CONSIDERATION OF AND/OR ANY APPROPRIATE ACTION ON PANORAMA STREET PRELIMINARY PLAT, SITUATED IN THE PHILLIP ANDERSON SURVEY, ABSTRACT NO. 10 CITY OF PARKER, COLLIN COUNTY, TEXAS. [MACHADO]

Re: Panorama Street
 Preliminary Plat and Engineering Plan Review

As you requested, we have reviewed the Preliminary Plat & Engineering Plans for the Panorama Street Addition prepared by LJA Engineering, Inc. These documents include a new street and is therefore considered a major subdivision under section 155.025 of subdivision ordinance.

PAVING DETAILS

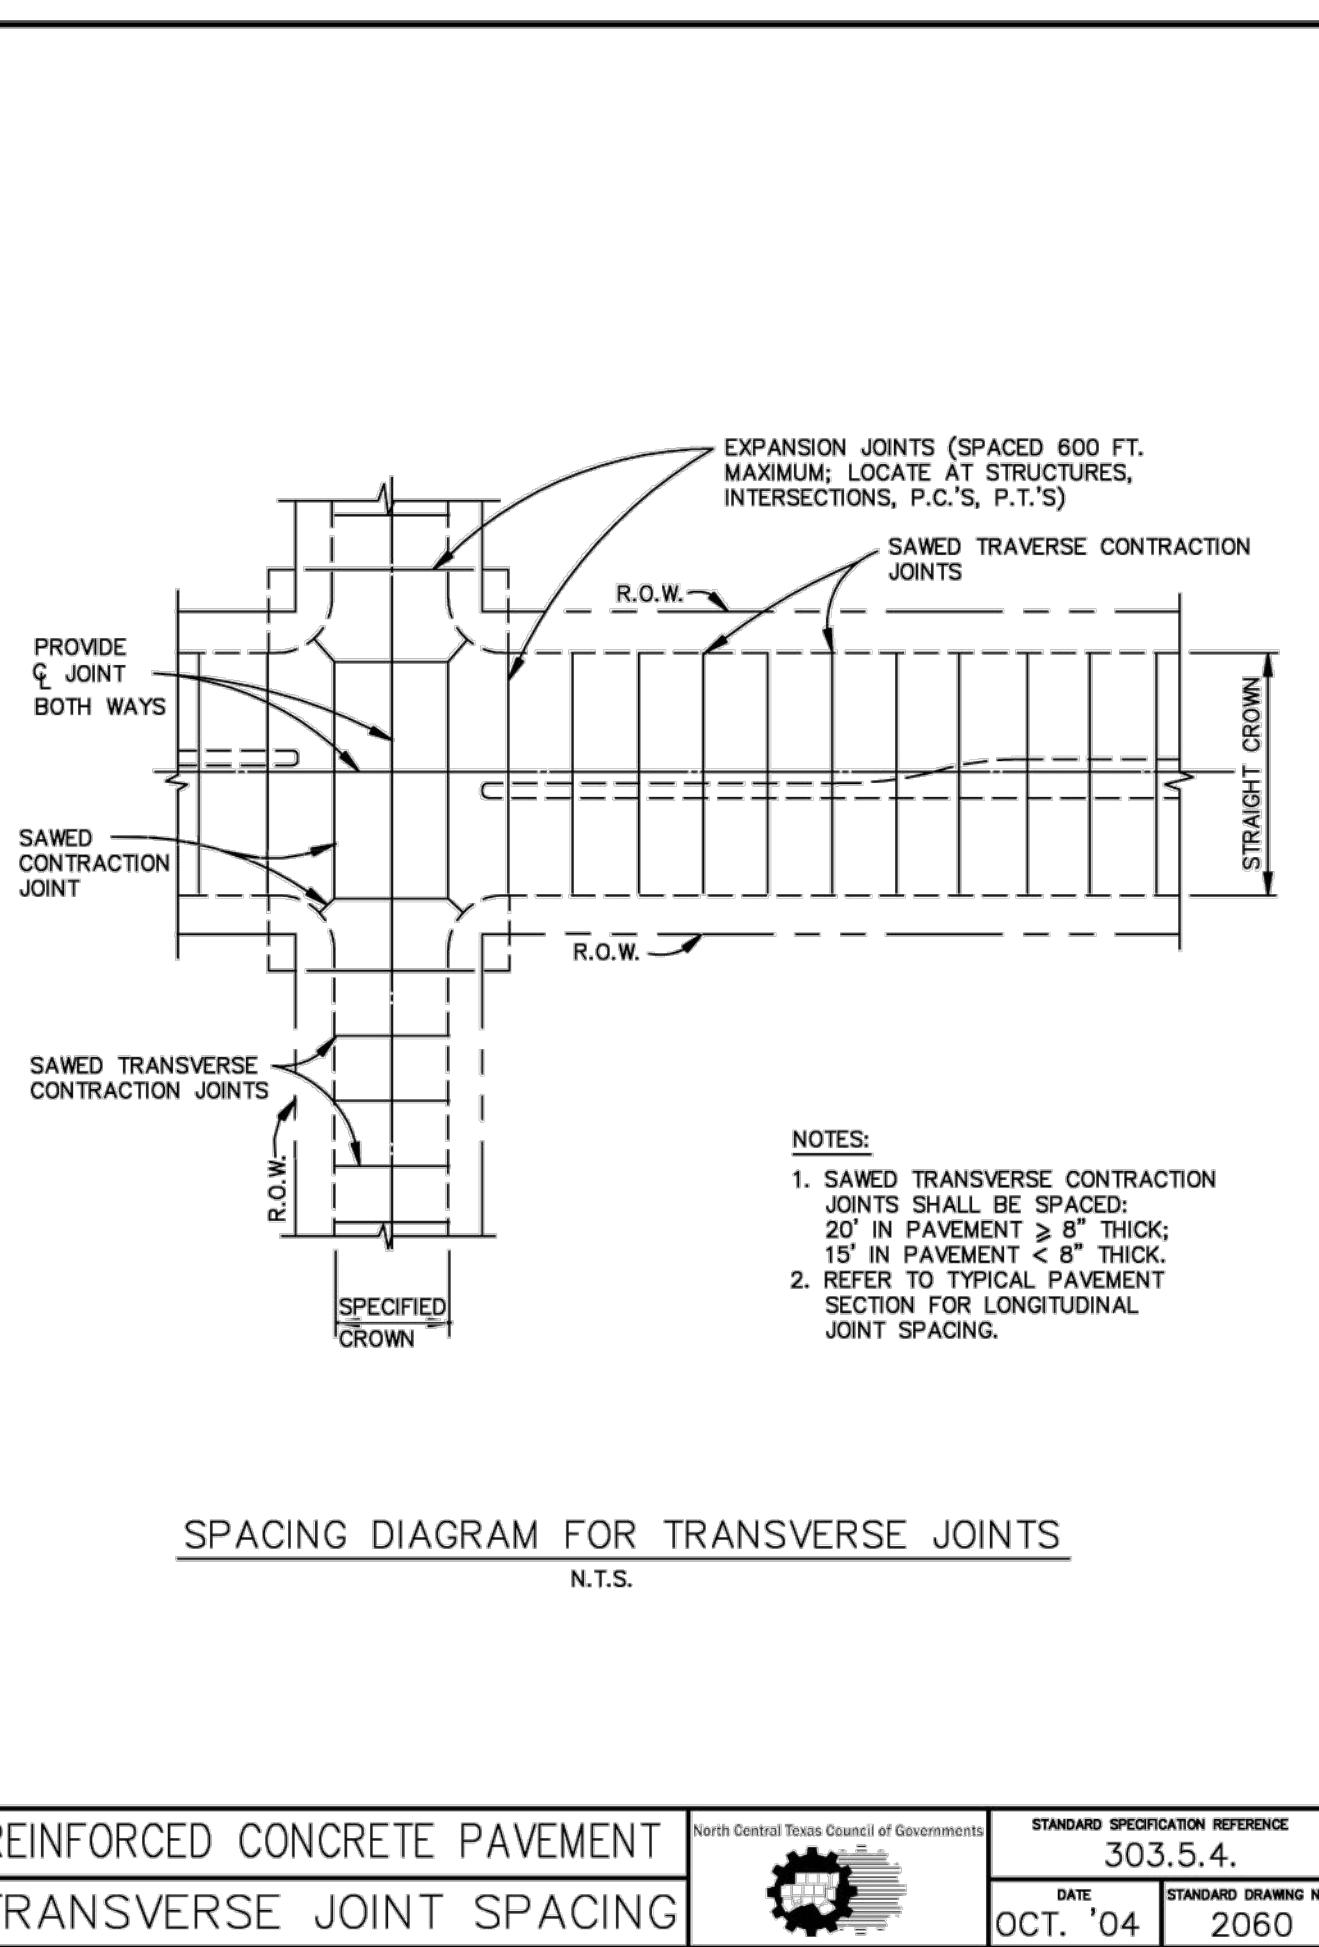
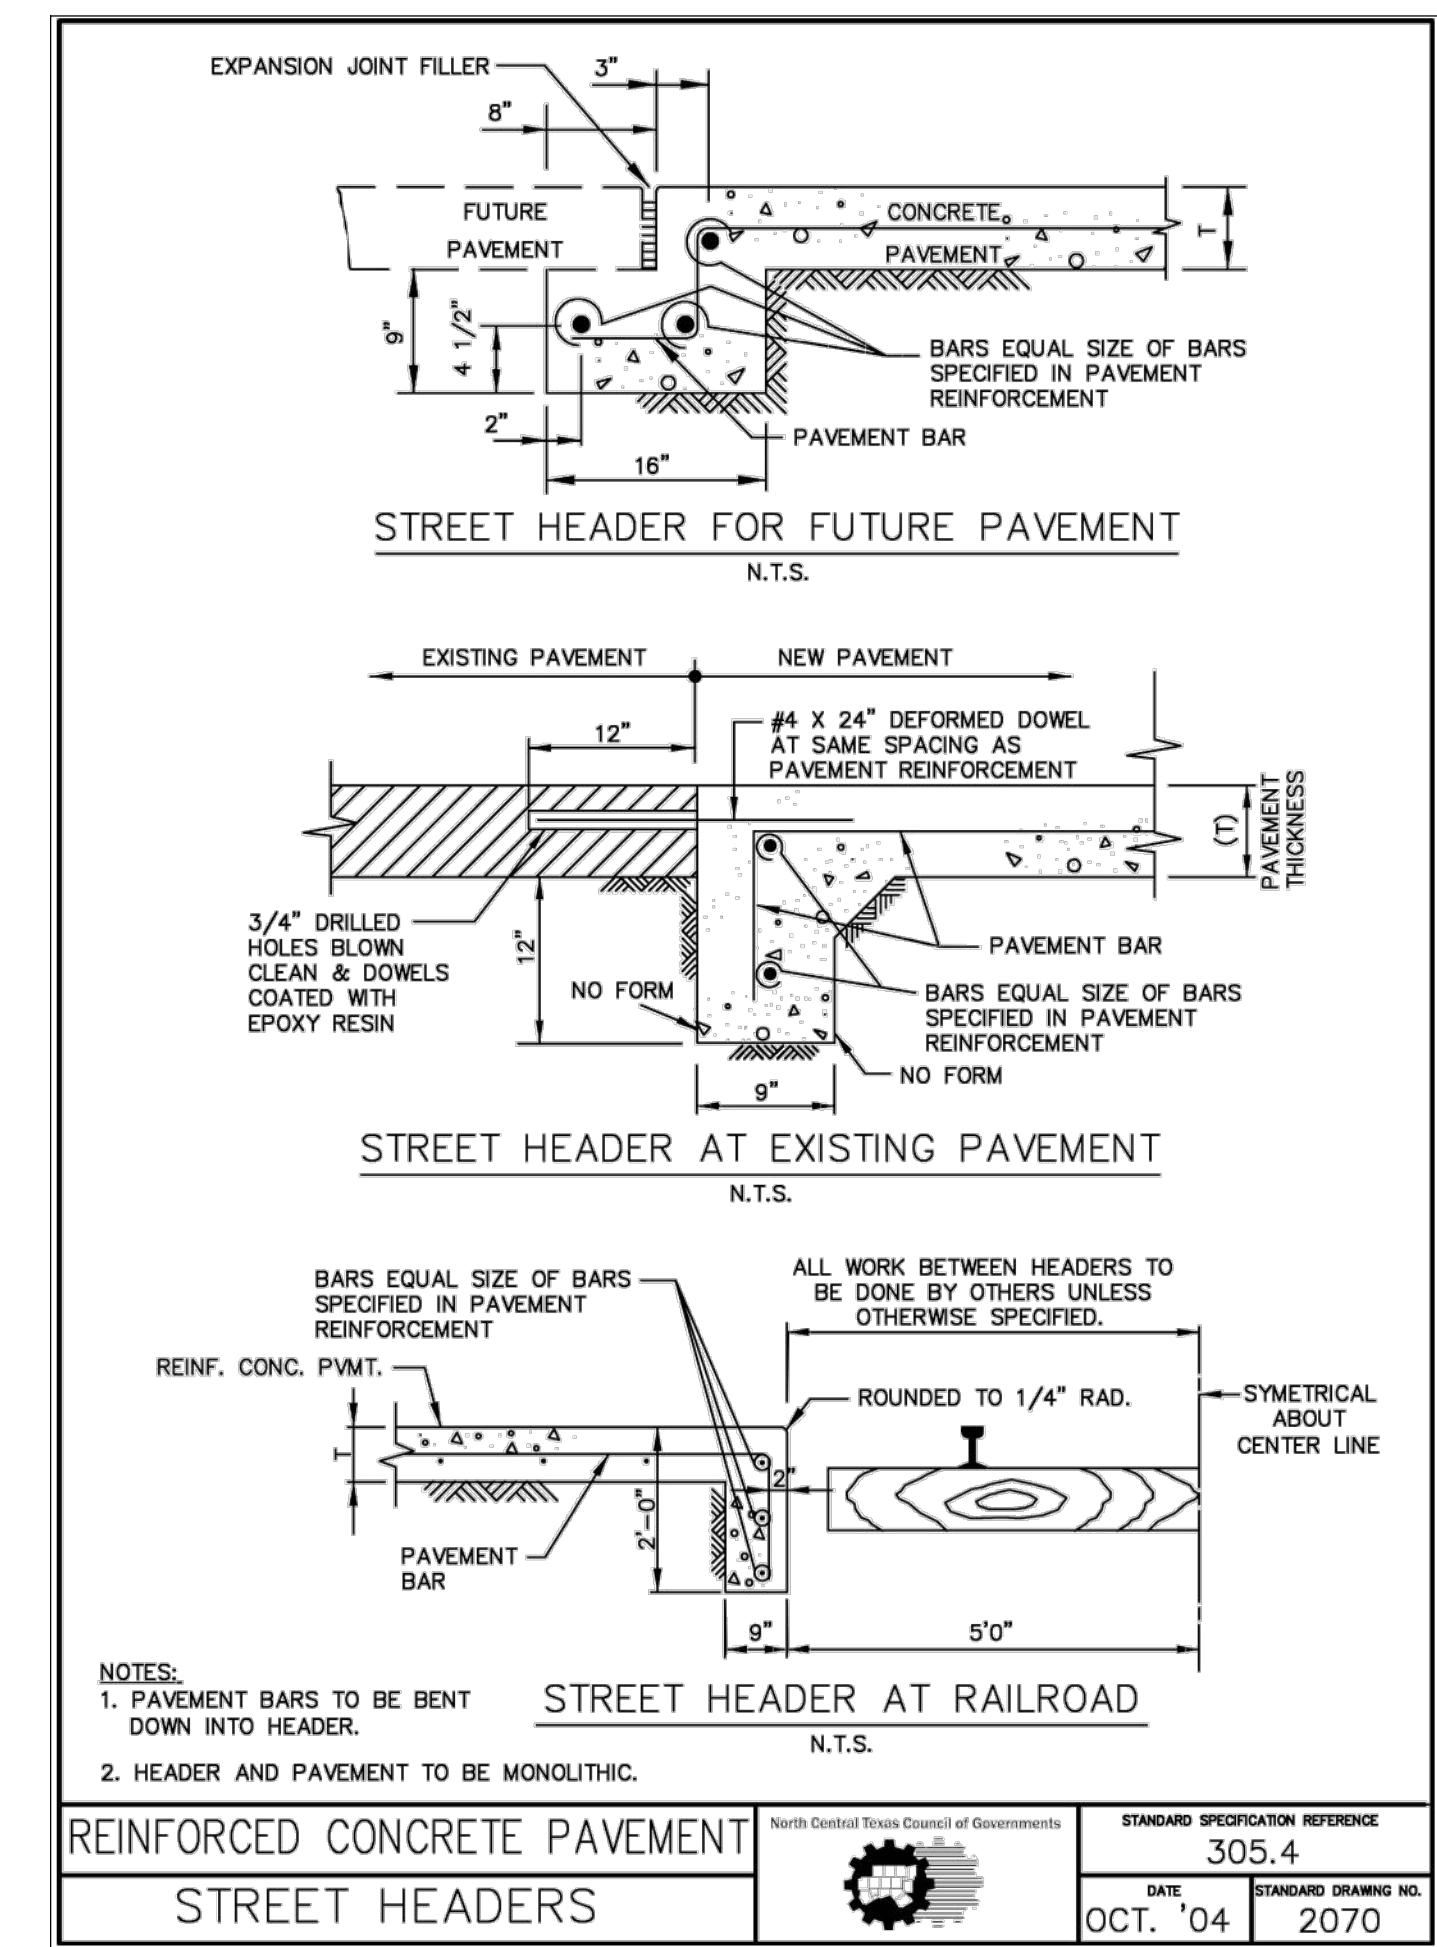
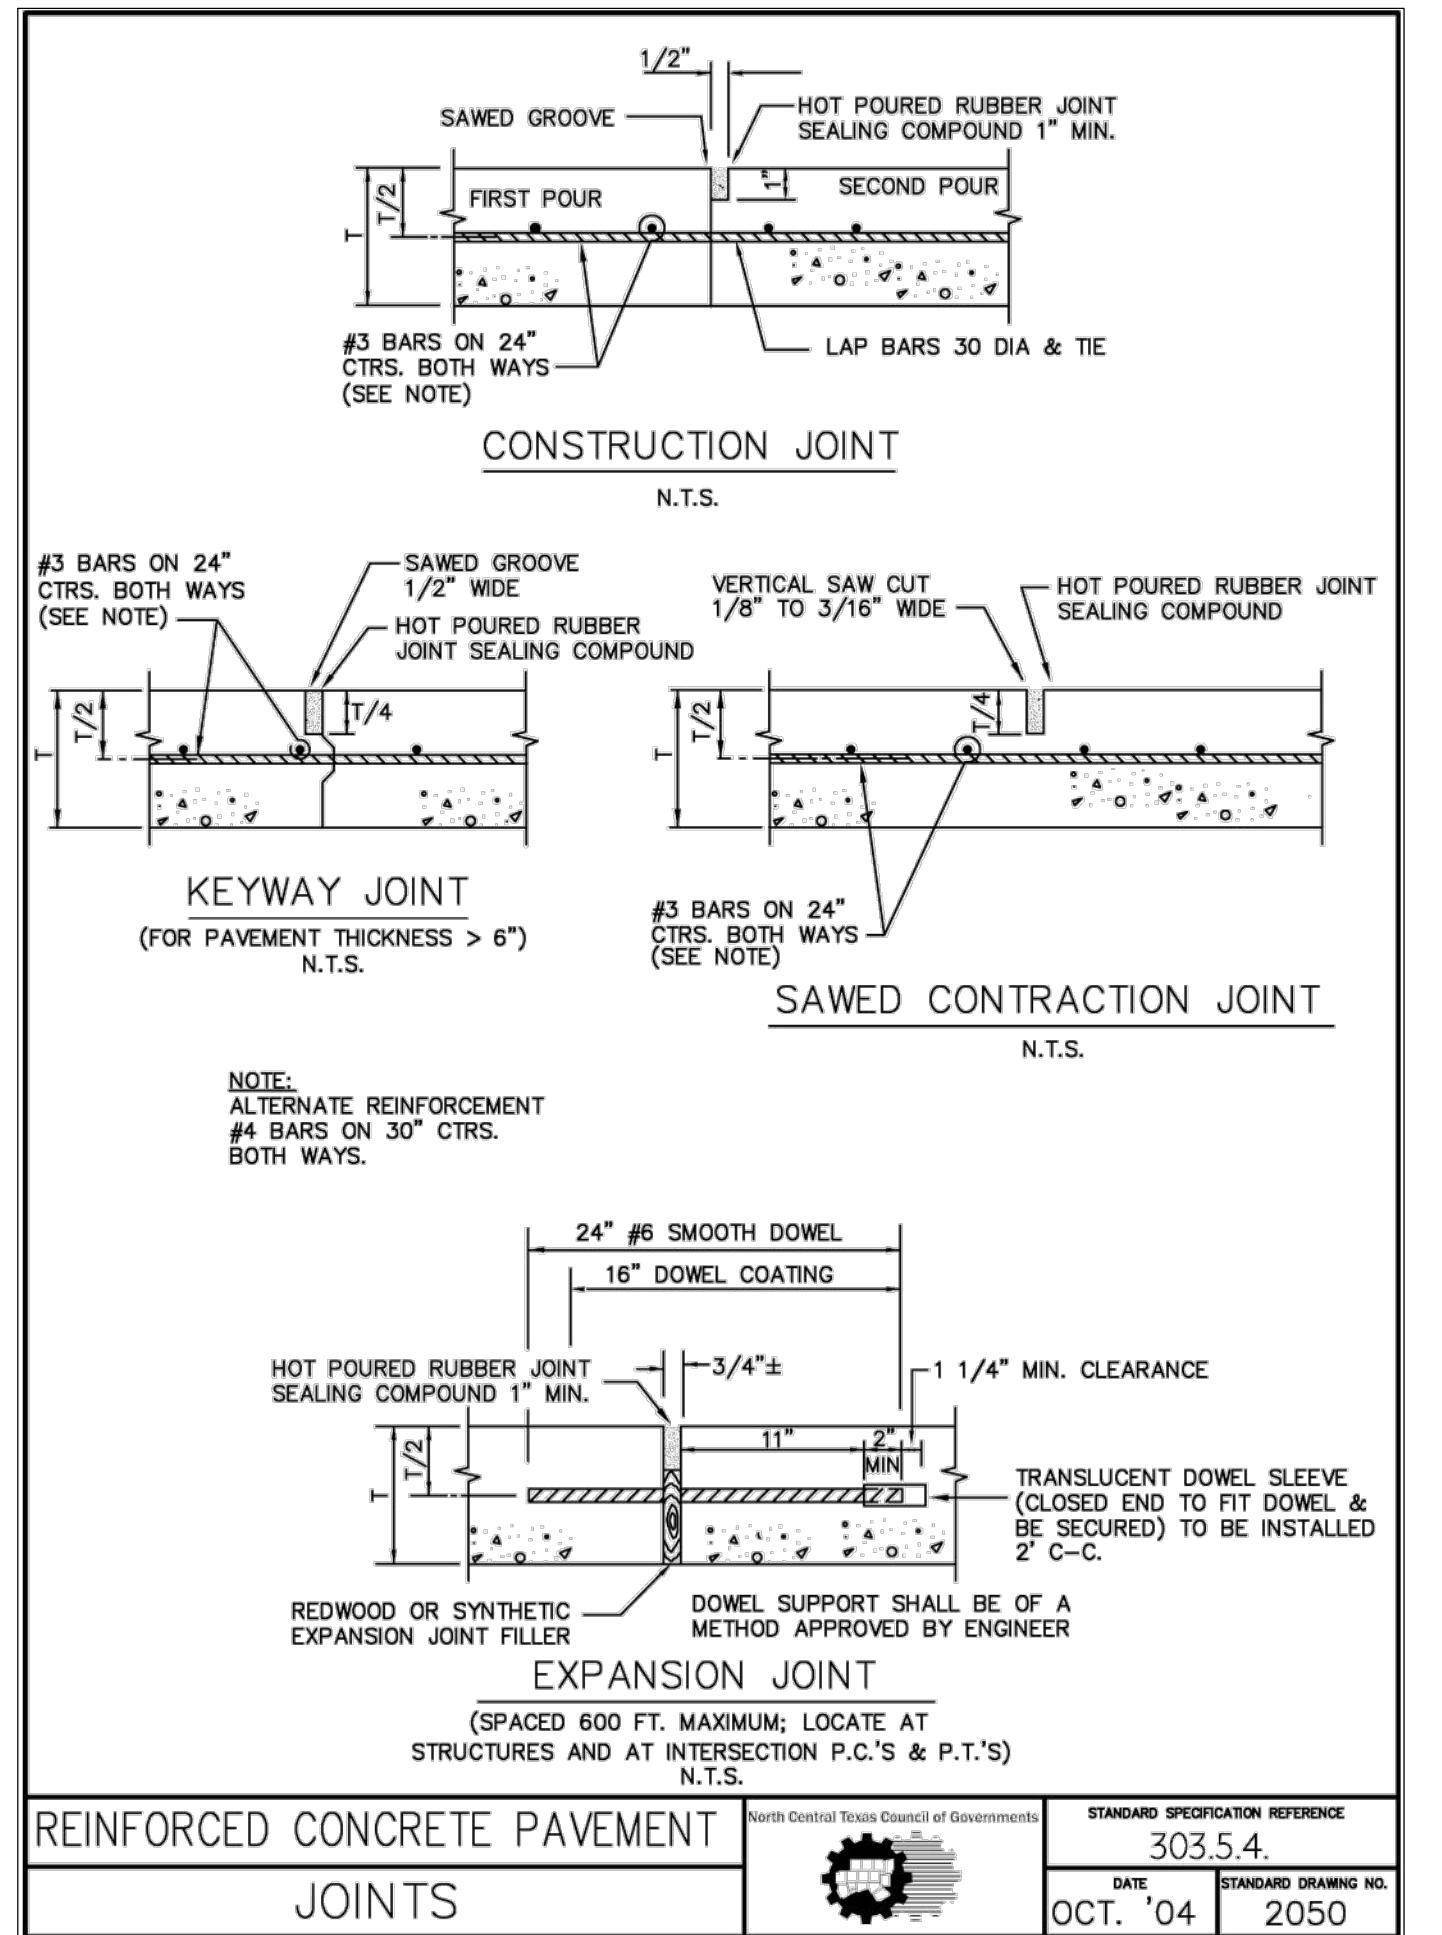
90. Sheet 34 Driveway approach and Street Headers at railroads do not apply. There are no driveways proposed off the street and there are no railroads in the City of Parker.
